**Charleston Armory HVAC Renovations
And Architectural Improvements
DEFK - 9013**

Addendum No.: 2
Issue Date: May 12, 2009
Architects Project No.: 115063
Bid Opening: 1:30 p.m. May 20, 2009

From: **Michael Baker Jr., Inc.**
5088 Washington Street, West
Charleston, West Virginia 25313

Drawing Number:
M1.2
 Sheet 1 of 1

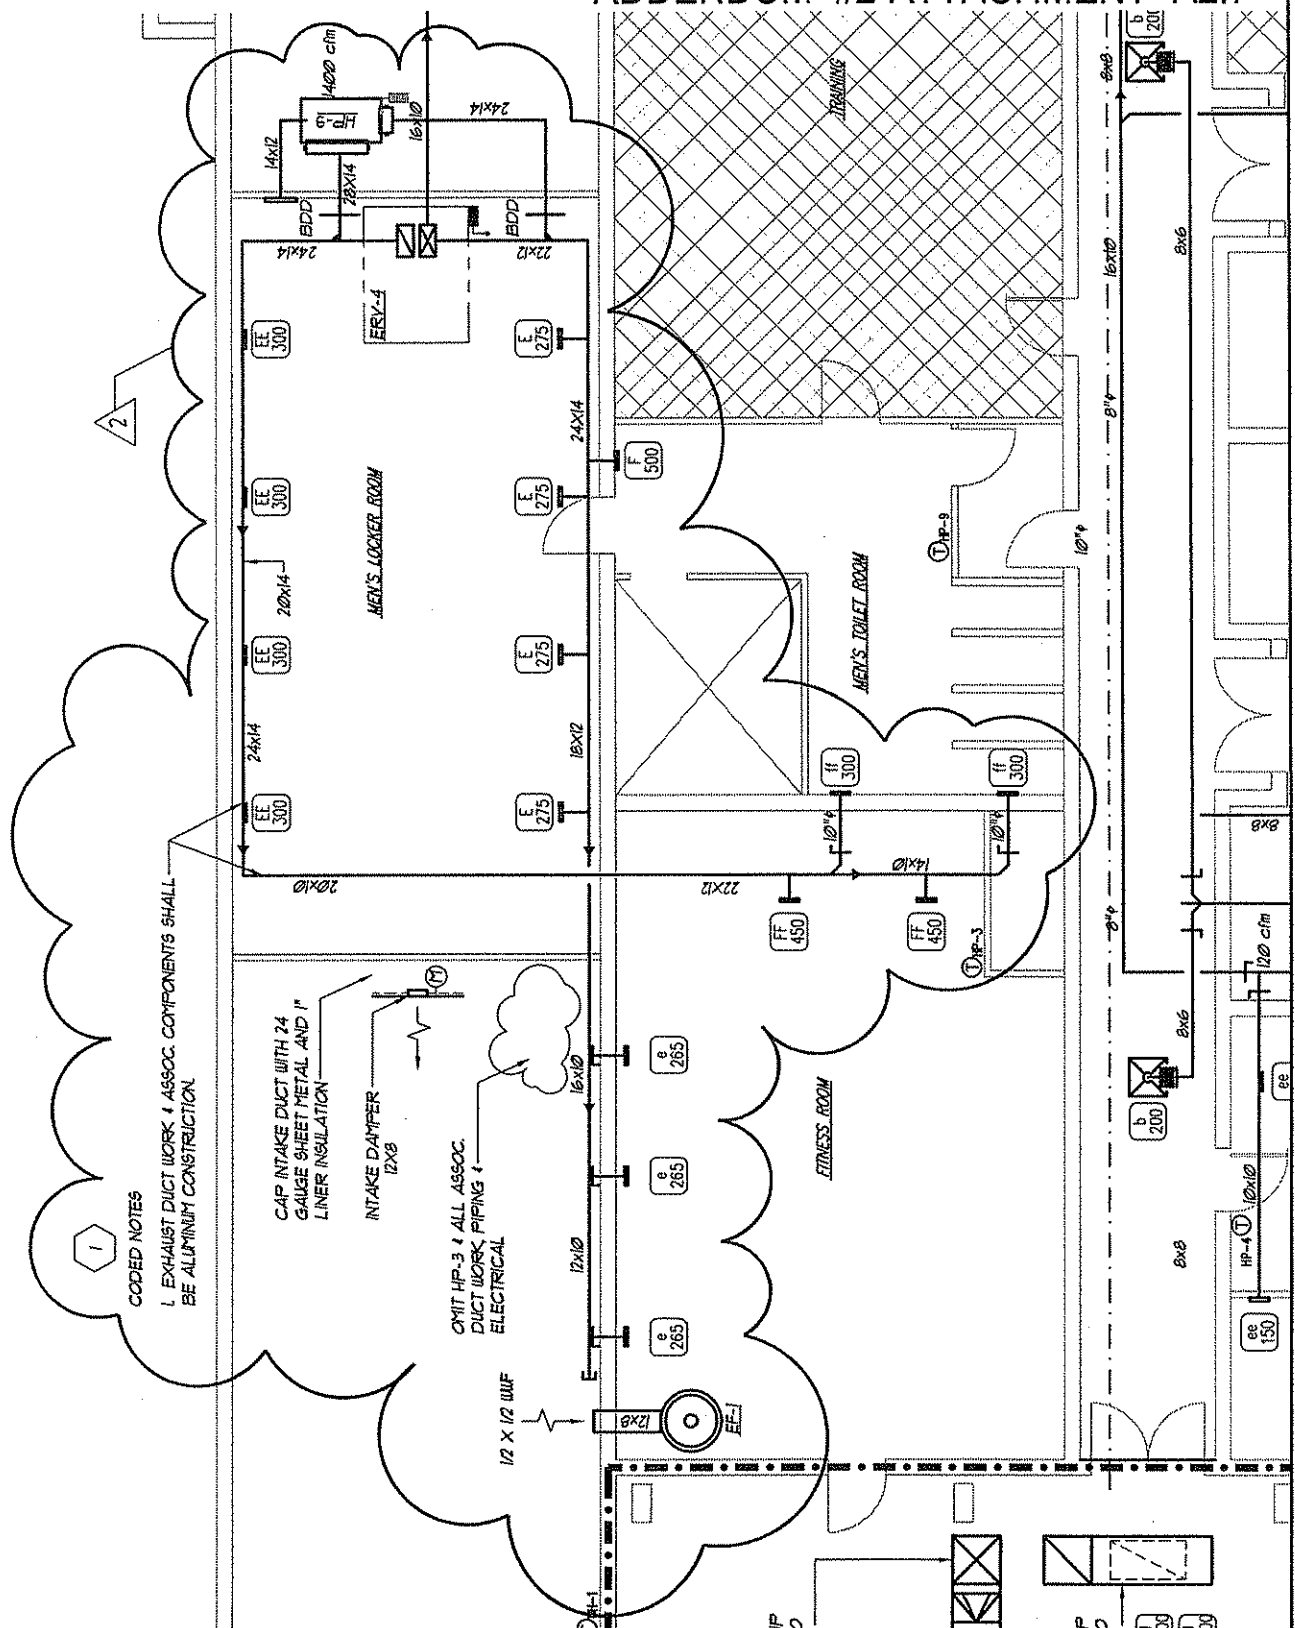
37. REVISE Drawing M1.1 per attachment A2.6. Revise duct configuration and size of ERV-5
 38. REVISE Drawing M1.2 per attachment A2.7. Omit HP-3 and associated ductwork, piping & electrical components. Revise layout, ERV size and components accordingly.

|  <p>Baker BAKER & ASSOCIATES A unit of Michael Baker Corporation</p> | <p>Michael Baker Jr., Inc. 5088 West Washington St. Charleston, West Virginia 25313 (304) 769-0821</p> | <p>Drawing Title: 1ST. FLOOR PARTIAL HVAC PLAN</p> | <p>Date: 5/11/09</p> | <p>Drawing Number: M1.1 Sheet 1 of 1</p> |

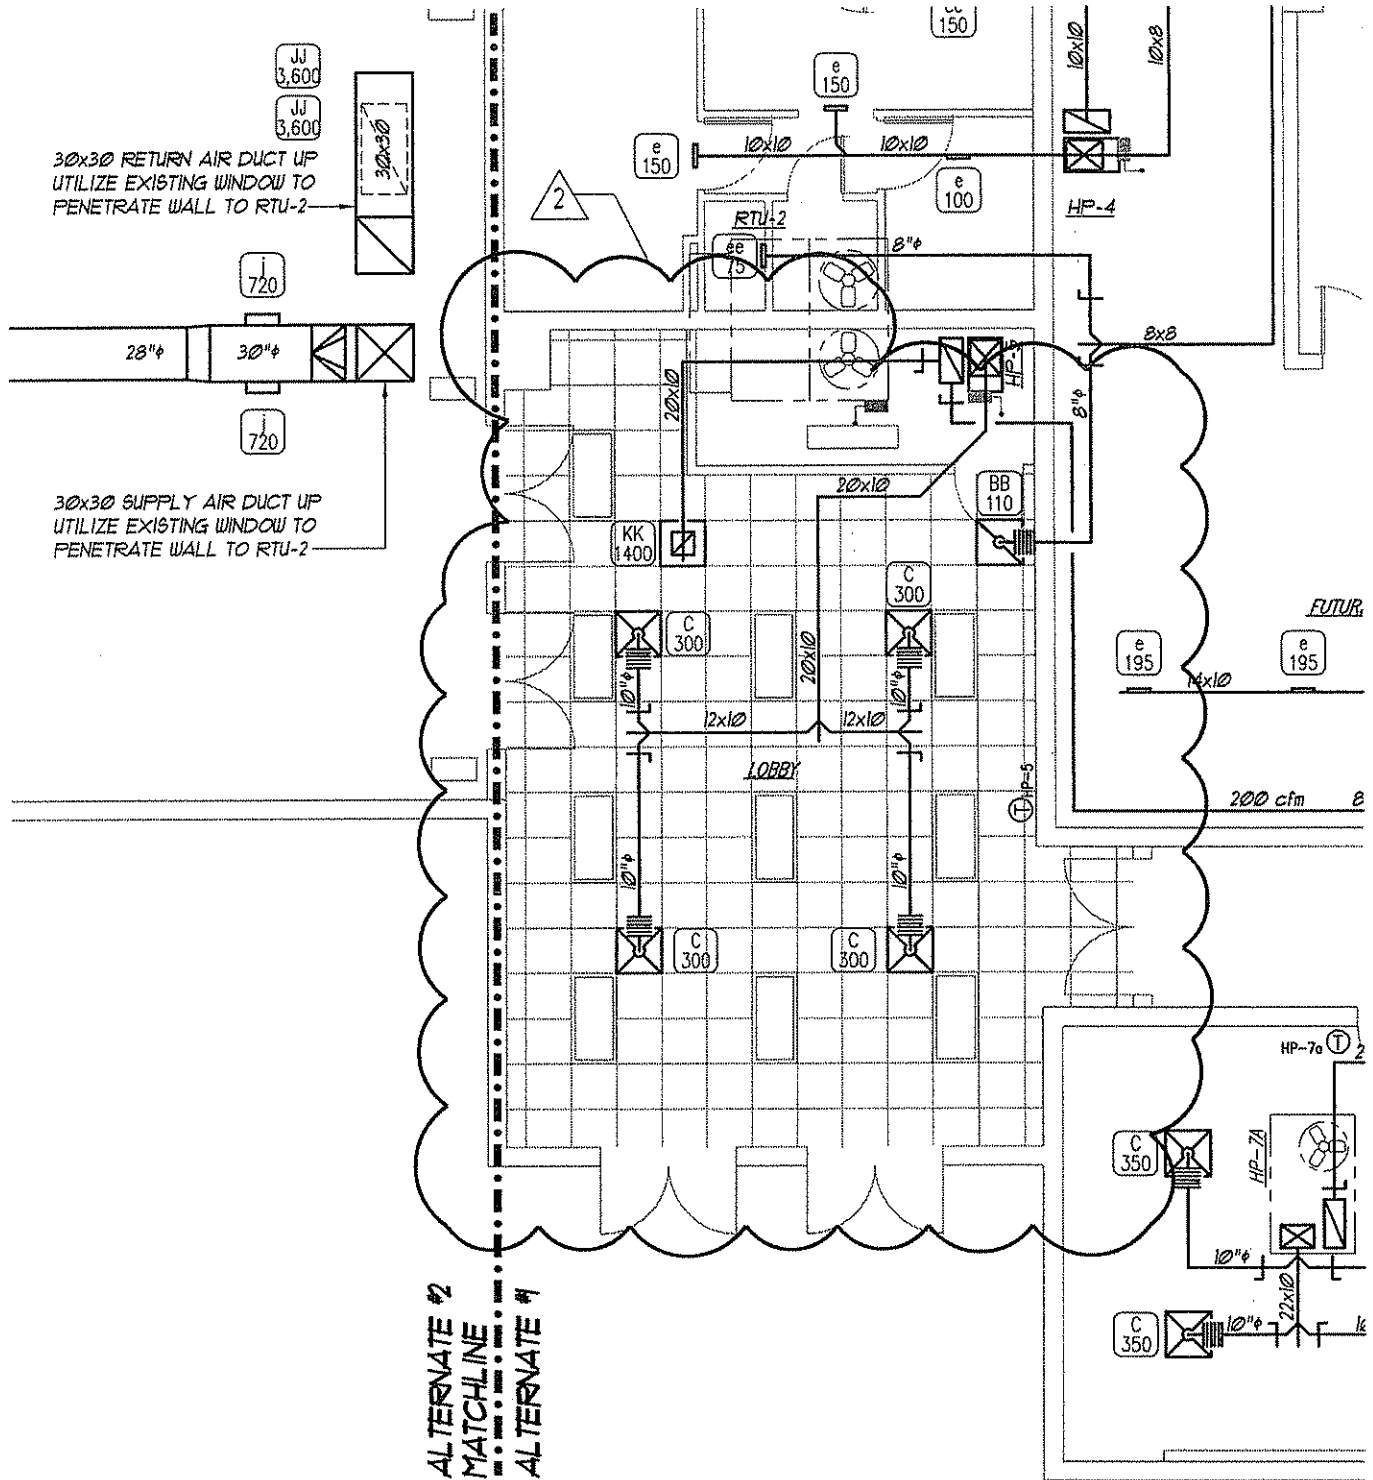
42. REVISE Drawing M1.1 as per Attachment A2.11. This drawing is titled "Mail Room Revision."
43. REVISE Drawing M1.2 as per Attachment A2.12. This drawing is titled "Lobby Duct Revision."

Drawing Number:
MO.1
Sheet 1 of 1

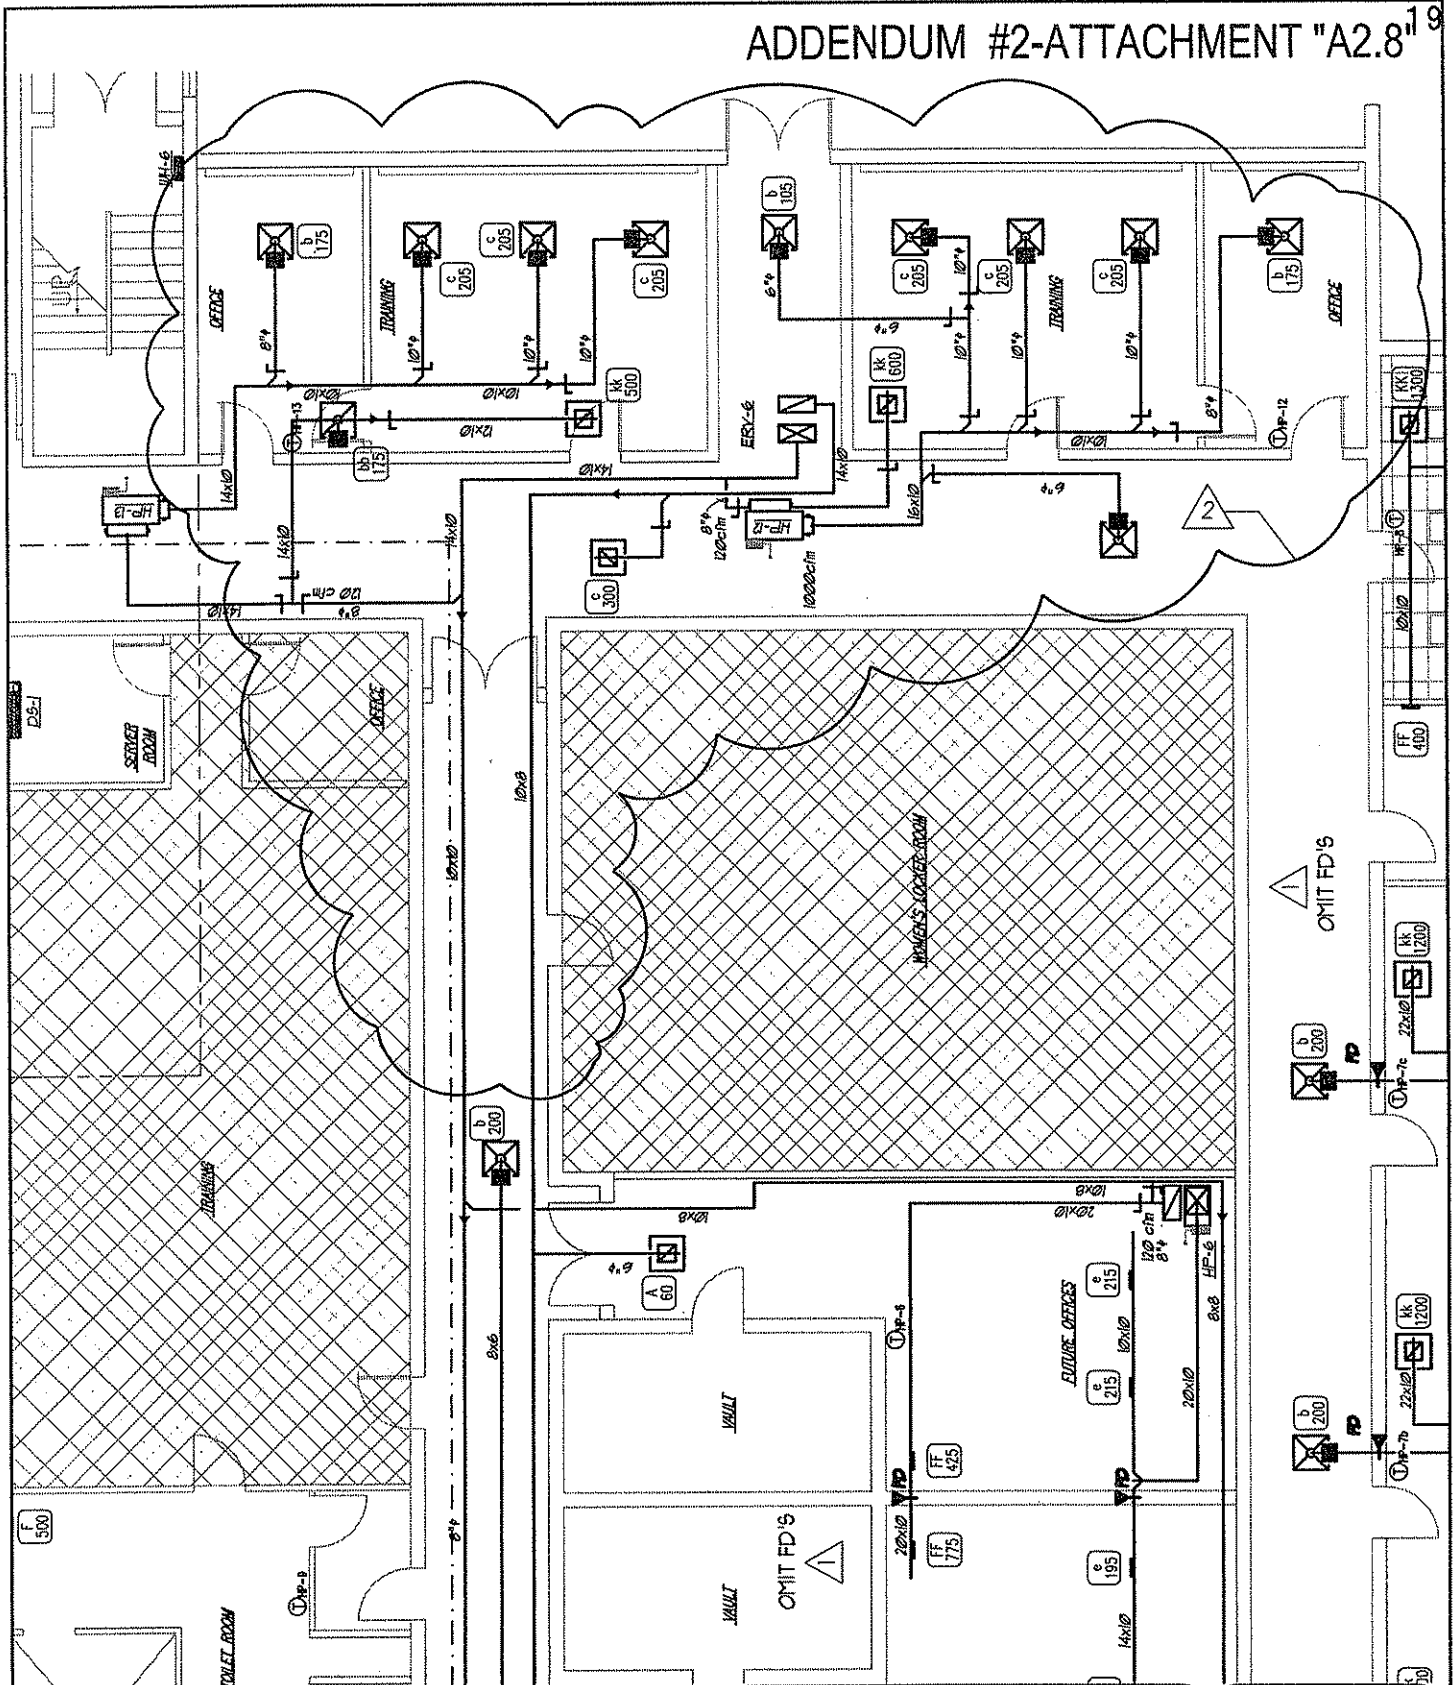
40. REVISE Drawing M1.2 per attachment A2.9. Drawing is a continuation of sketch A2.8
 41. REVISE schedules on M0.1 per attachment A2.10.

Drawing Number:
M1.2

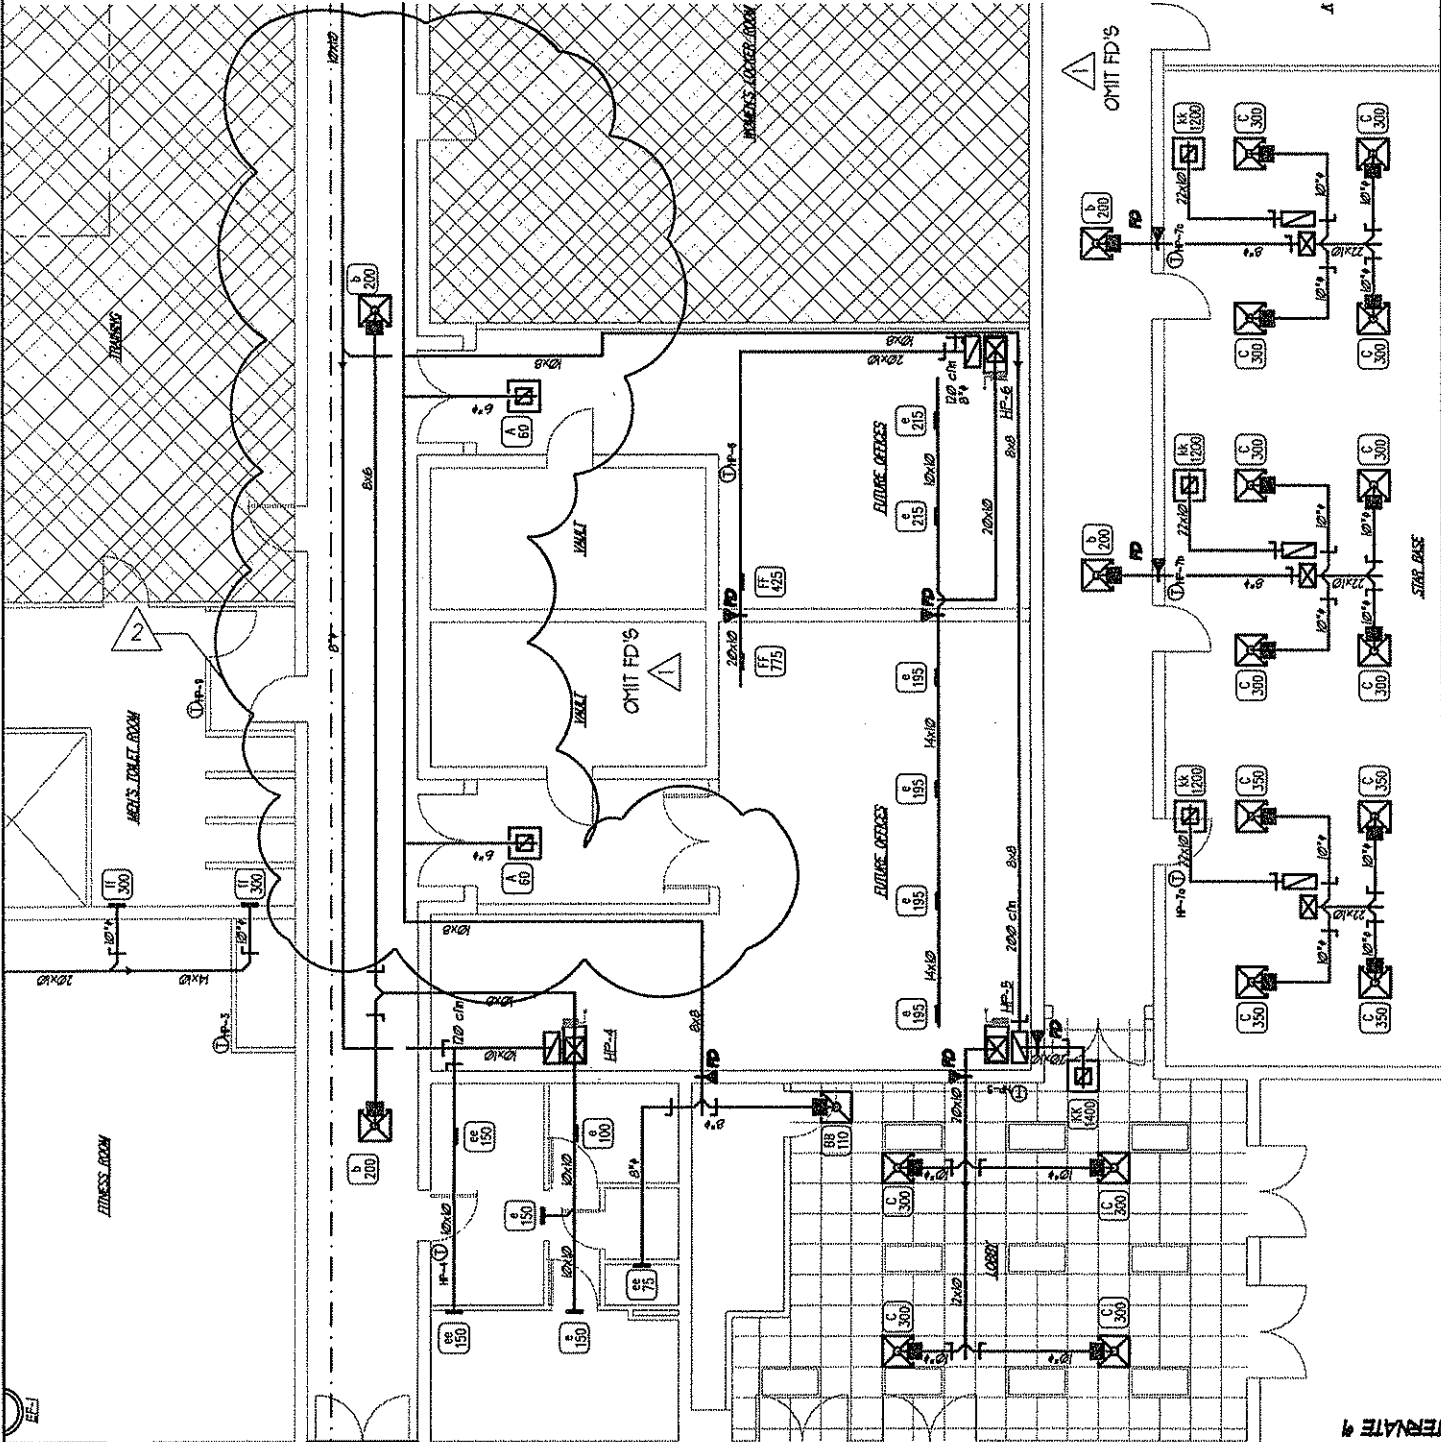
39. REVISE Drawing M1.2 per attachment A2.8. Revise and relocate HP-12 into ceiling space and add ERV-6 and associated ductwork, piping, electrical and components.
